# Rezoning Transportation Analysis

Petition Number: 2019-071

## Revision Log:

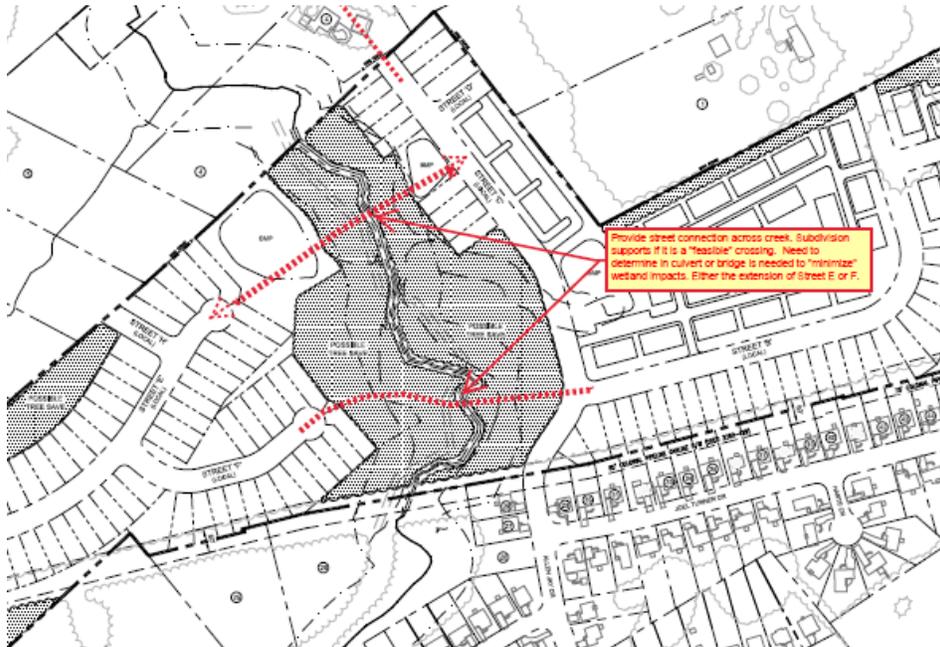
1. ~~**Curbline** The proposed zoning district has a setback measured from back of the existing or proposed future curbline.~~
  - a. ~~**Road Name:** Sunset Rd. future back of curb is 24.0' as measured for the road's existing centerline. The City's Subdivision Ordinance (Chapter 20) requires the implementation of curb and gutter on Sunset Rd.~~
  - b. ~~**Road Name:** Oakdale Rd. future back of curb is 24.0' as measured for the road's existing centerline. The City's Subdivision Ordinance (Chapter 20) requires the implementation of curb and gutter on Sunset Rd.~~
